ADDENDUM NO. 02

DATE: April 29, 2020

PROJECT: Inglemoor High School Concert Hall + Music Building Project

Aluminum Curtain Wall Types

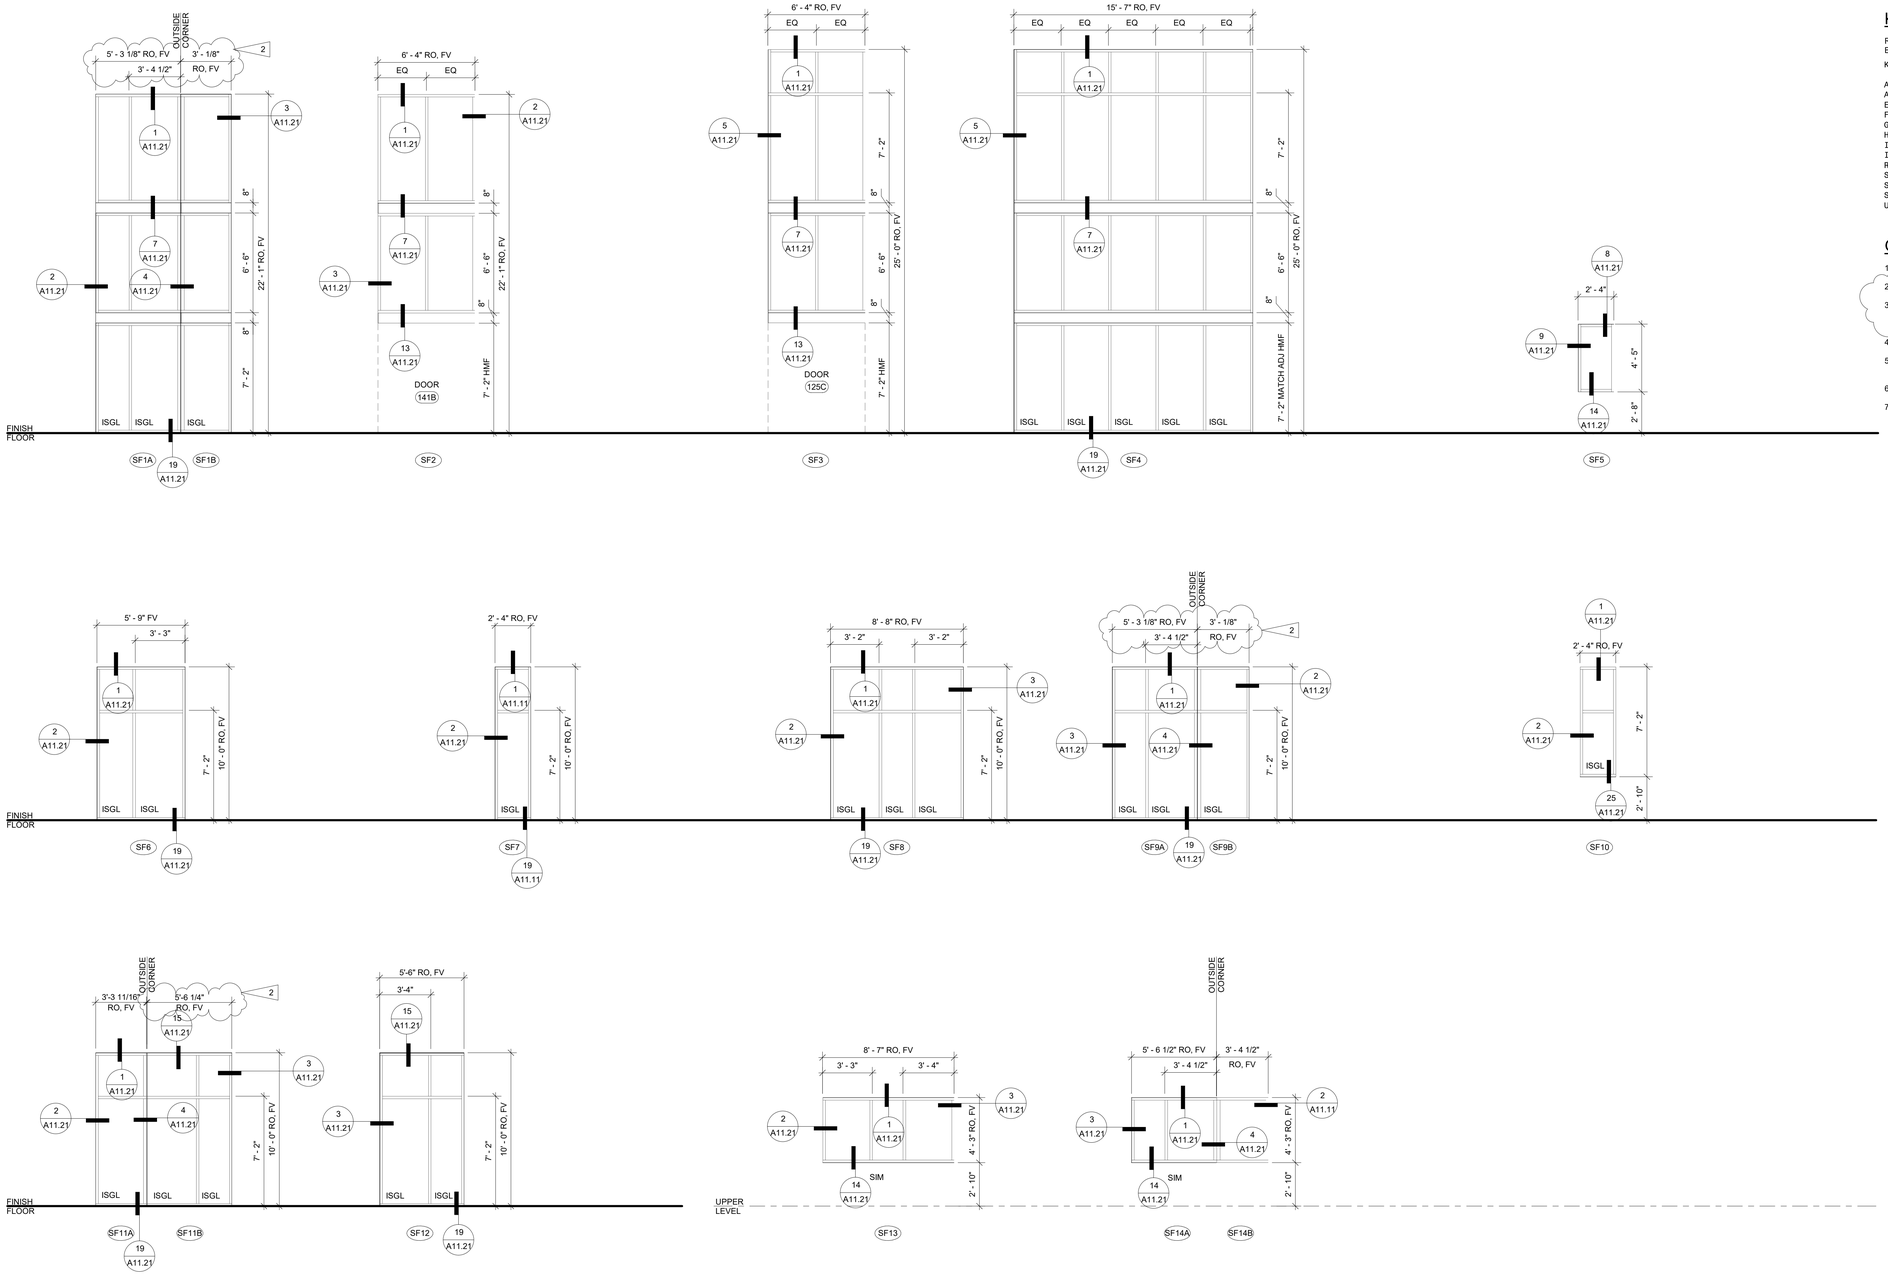
1. On Detail 1, Keylink Schedule and General Door & Window Notes, REVISE per attachment A11.10

4 BE201 REF.ARCH 11/A6.10 SECTION: FRAMING TO EXPOSED CONCRETE

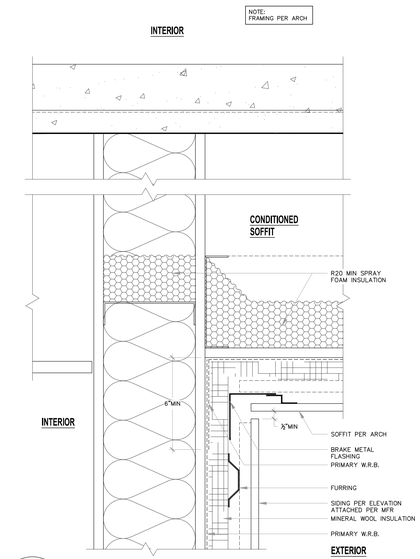
1. MODIFY Detail 4 – Referenced Architect Detail 11/A6.10

AIR BARRIER NOTES

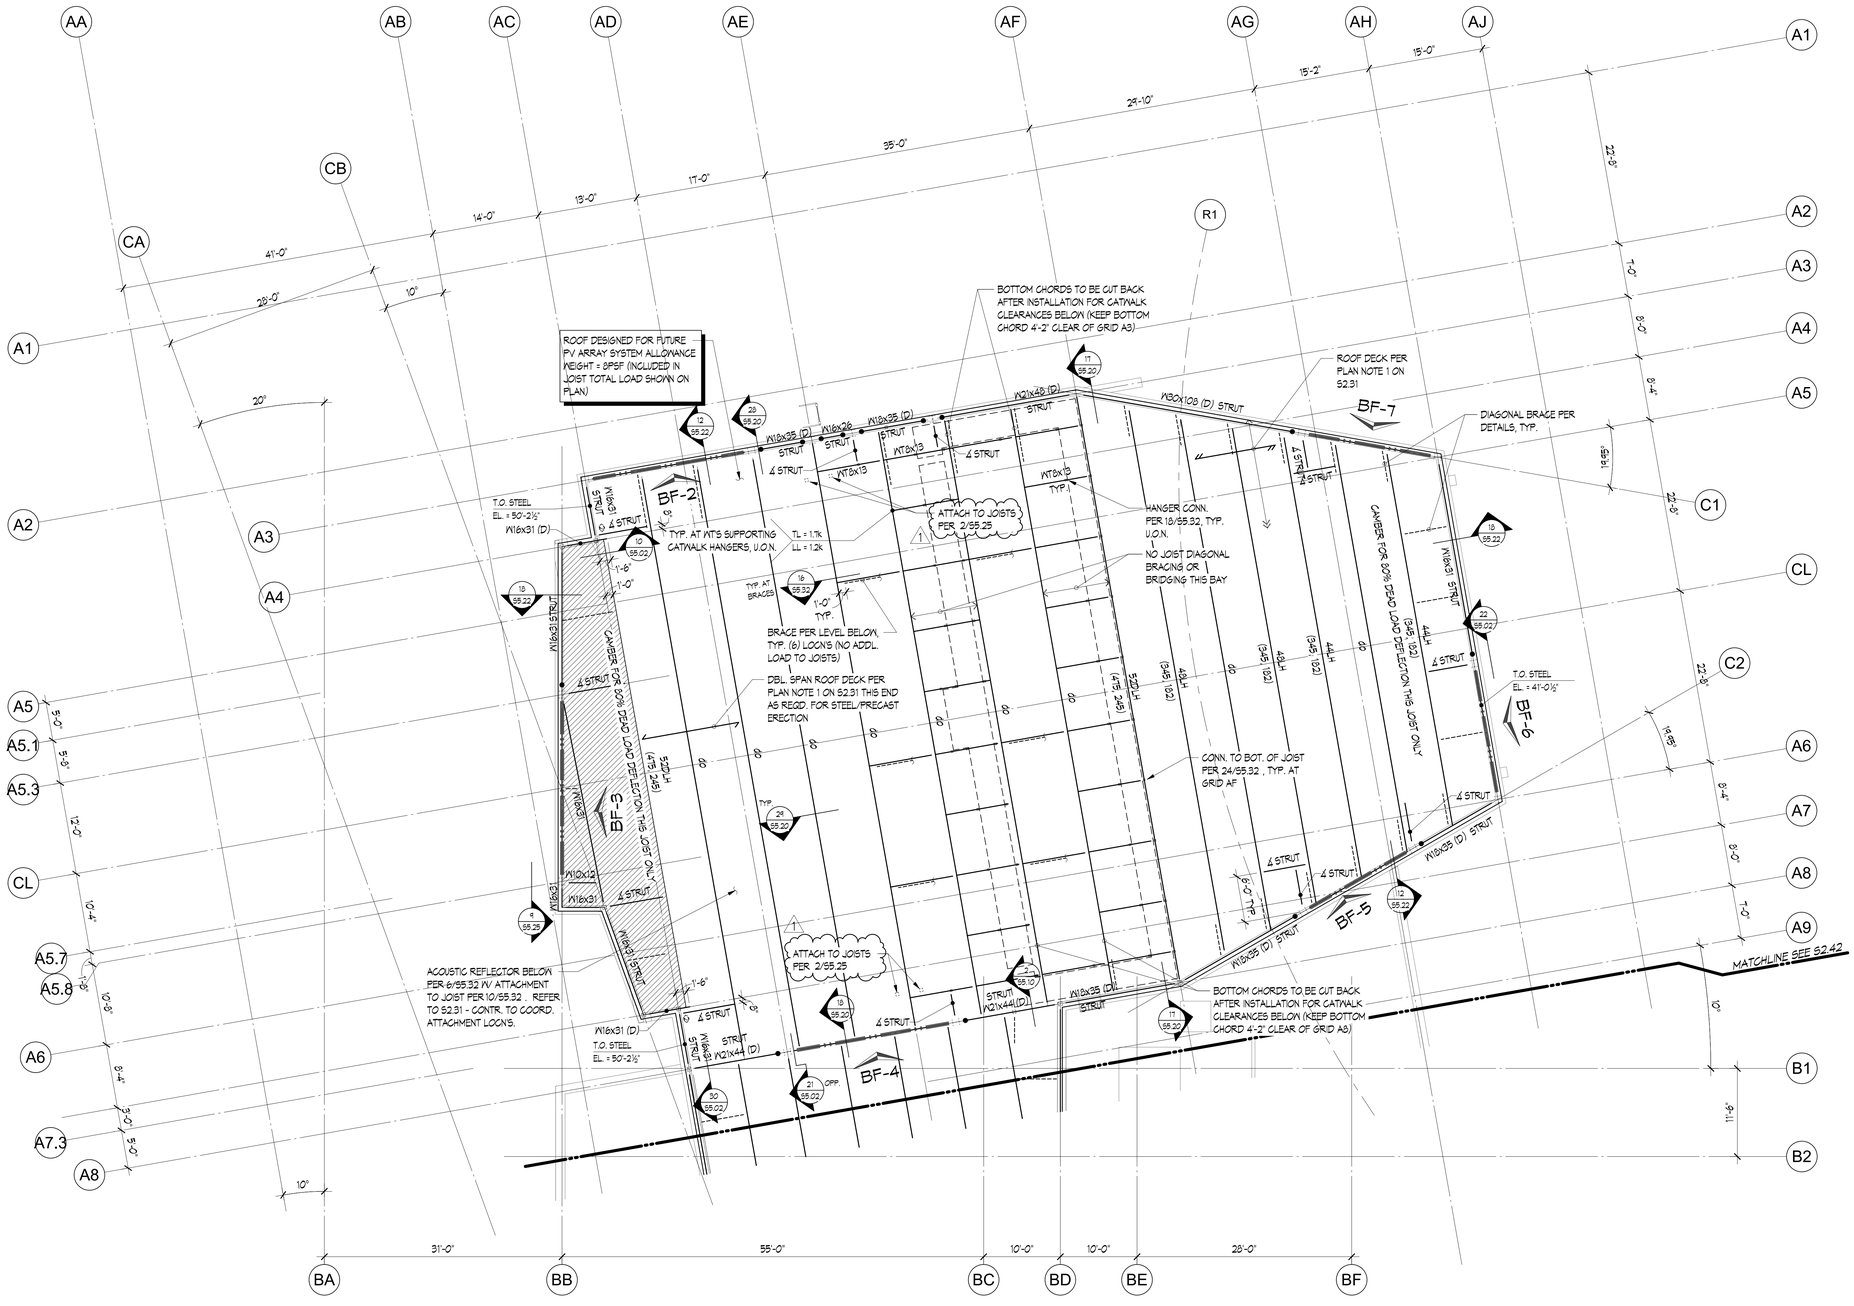
SHEET BE800 – Air Barrier Notes
1. MODIFY Section D – Updated part of first sentence to read "… building envelope shall not exceed 0.25 cfm/ft^2…"
2. MODIFY Building Envelope Air Leakage Calculations Table – Changed Max Allowed Air Leakage of Building Envelope to 0.25 cfm/ft^2

1 AREA A - HALL ROOF FRAMING PLAN

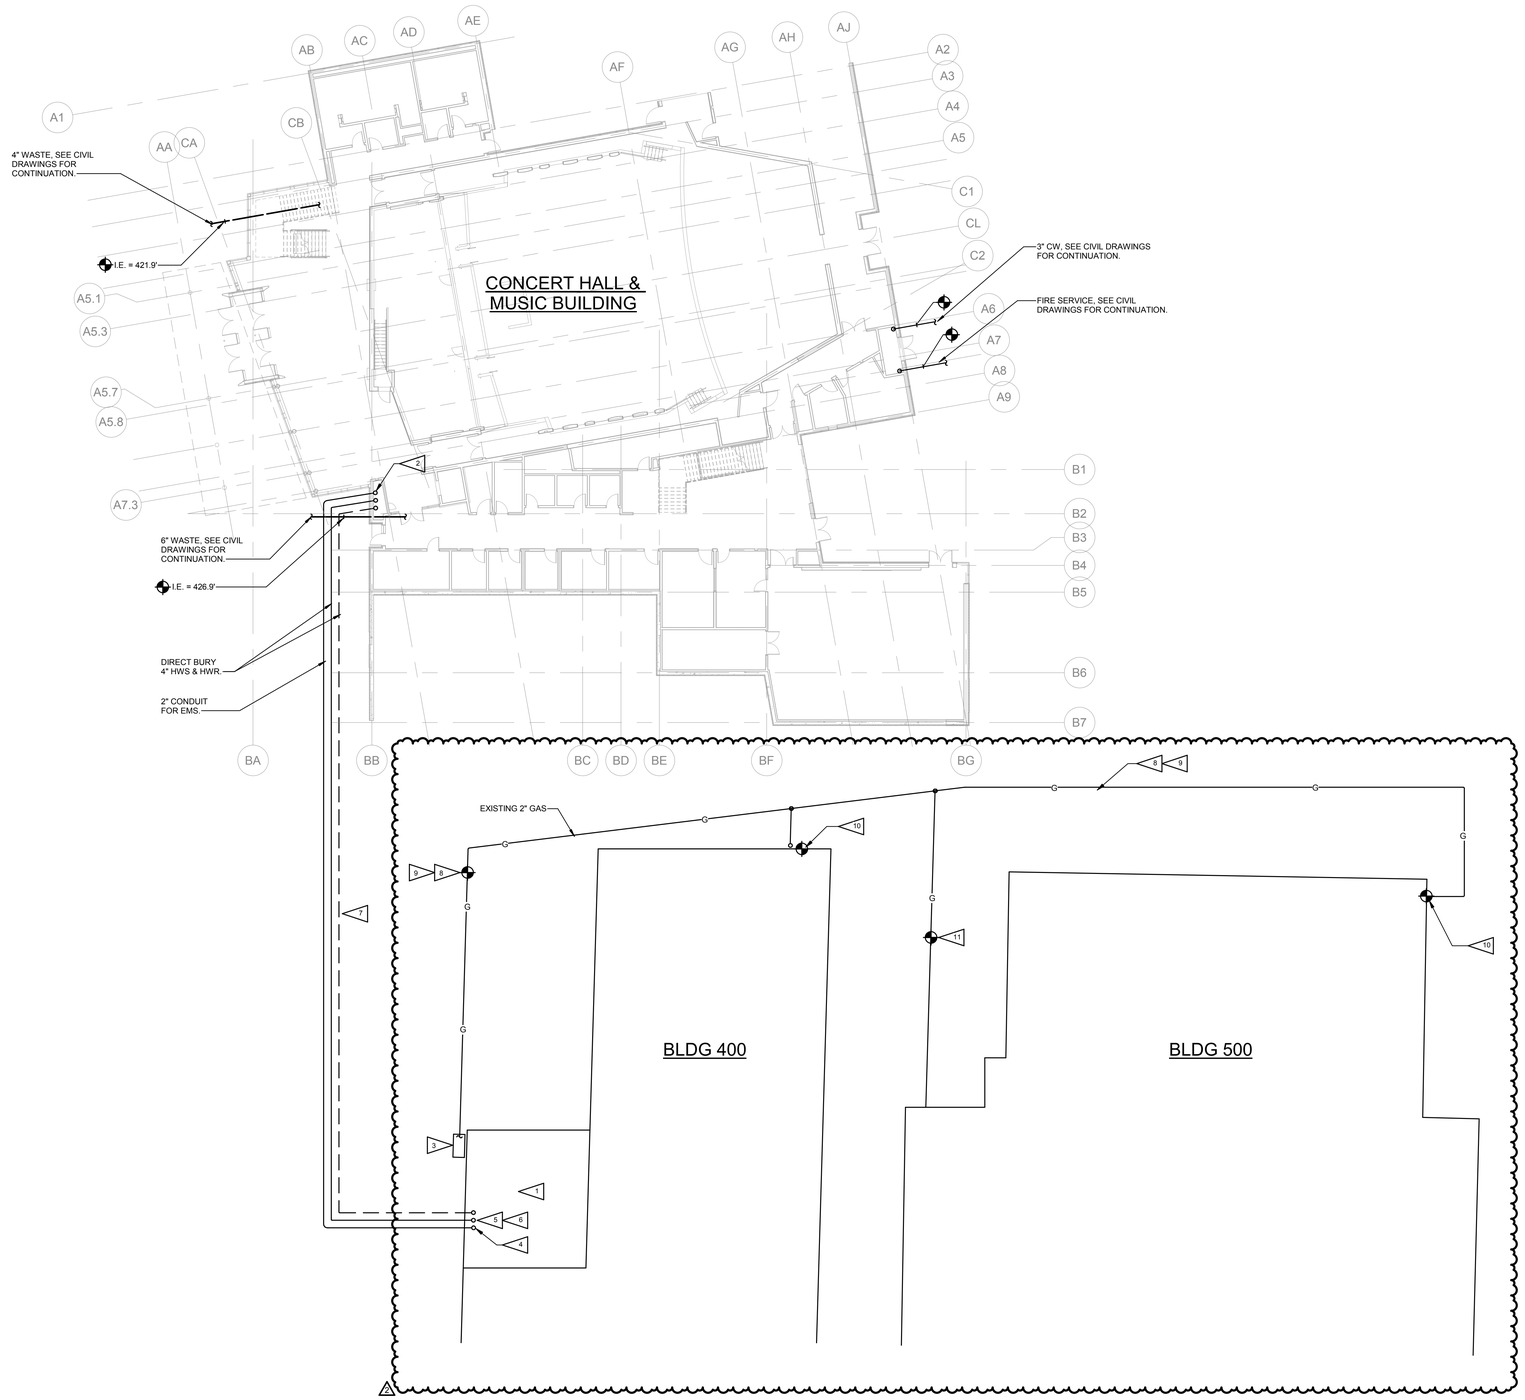
SHEET S2.41 – Area A – Hall Roof Framing Plan
1. DELETE "TYP. (4) LOCNS" from connection note near girds A7/AD. See revised S2.41.
2. ADD "ATTACH TO JOISTS PER 2/S5.25 note near grids A5/AE. See revised S2.41.

1 Area A - Lower Level - Lighting
1/8" = 1'-0"

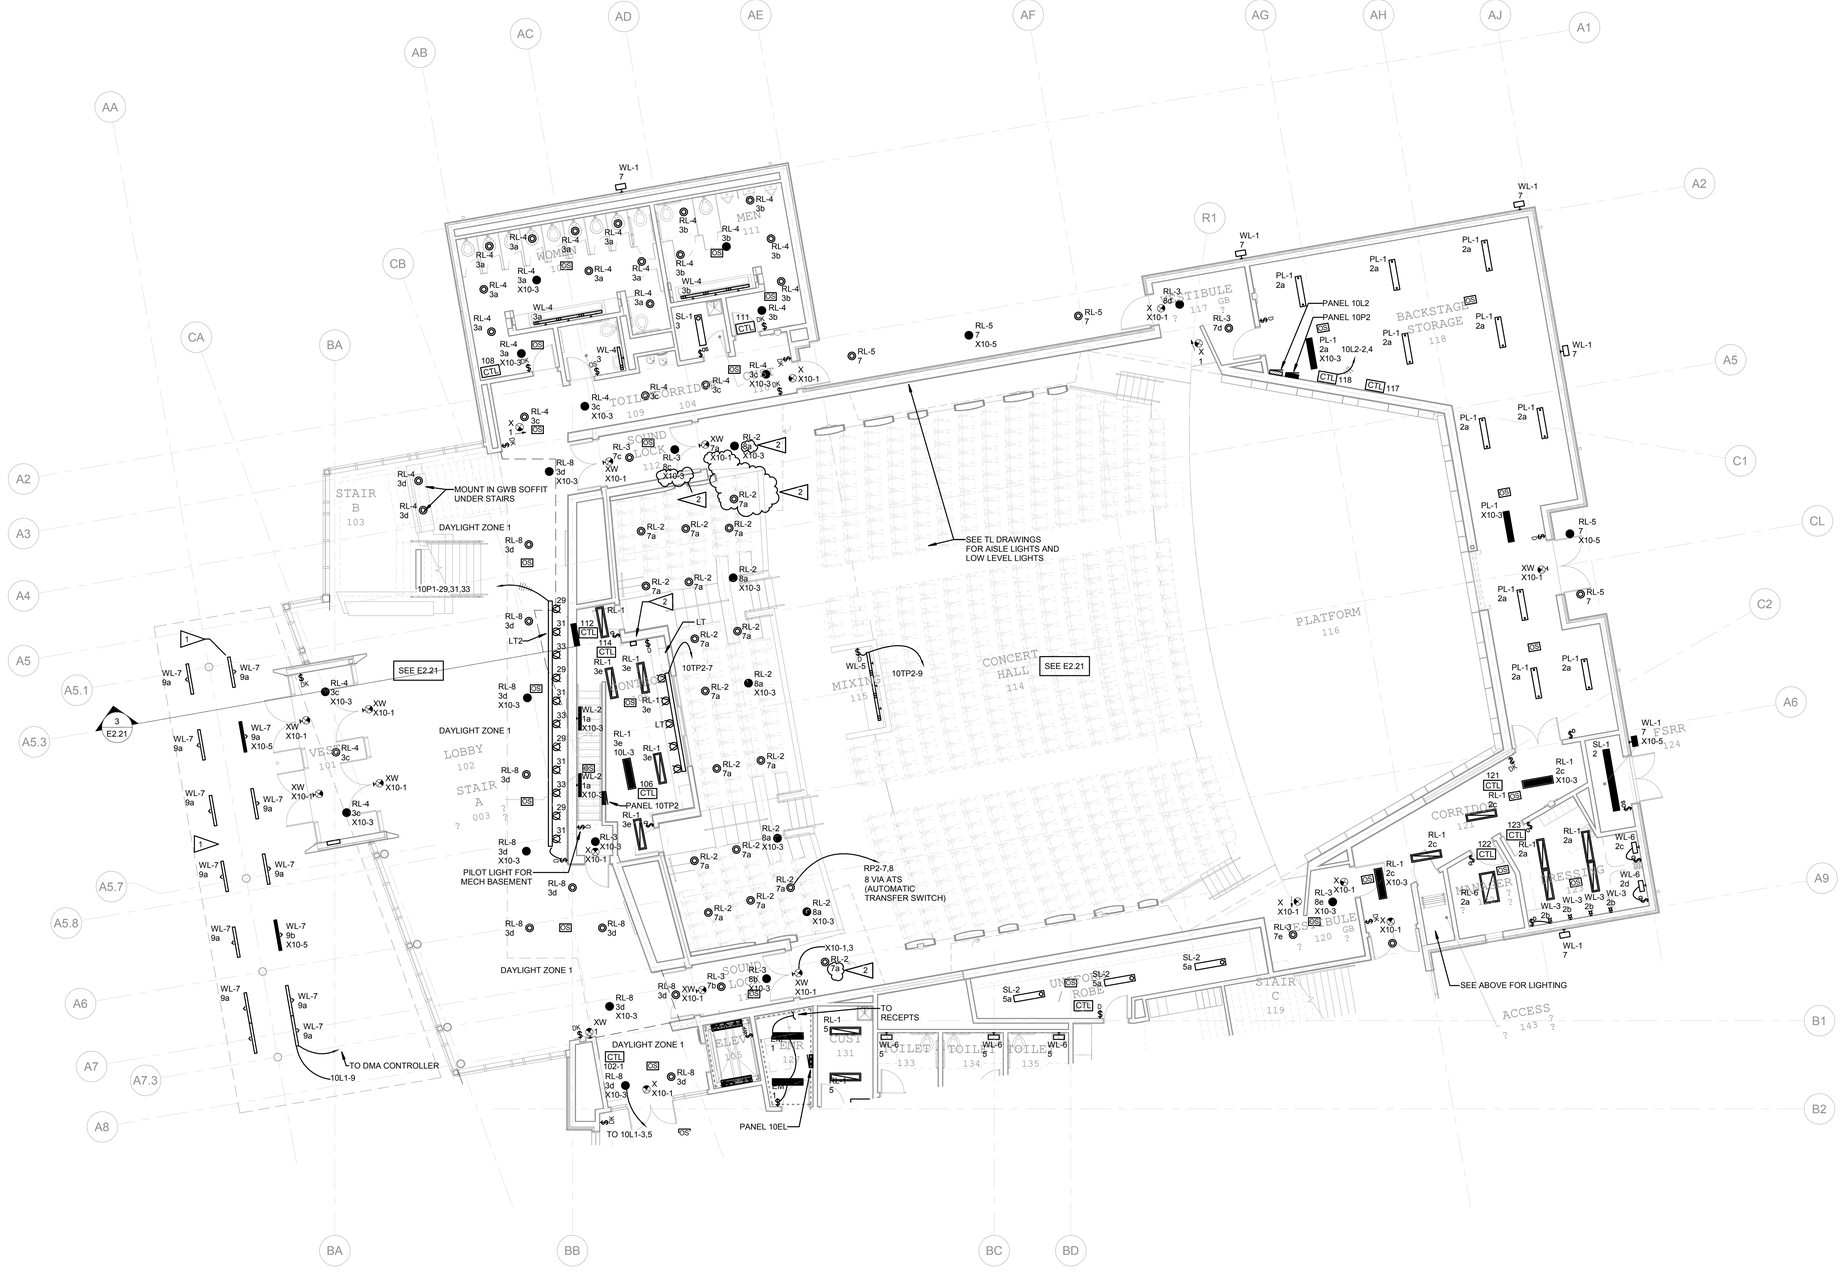
SHEET E2.11 – Area A – Lower Level – Lighting
1. REVISE: Call out at circuitry for WL-7 fixtures at exterior canopy to "TO DMX CONTROLLER".
2. REVISE: Lighting circuitry in Concert Hall as shown on attached updated sheet.
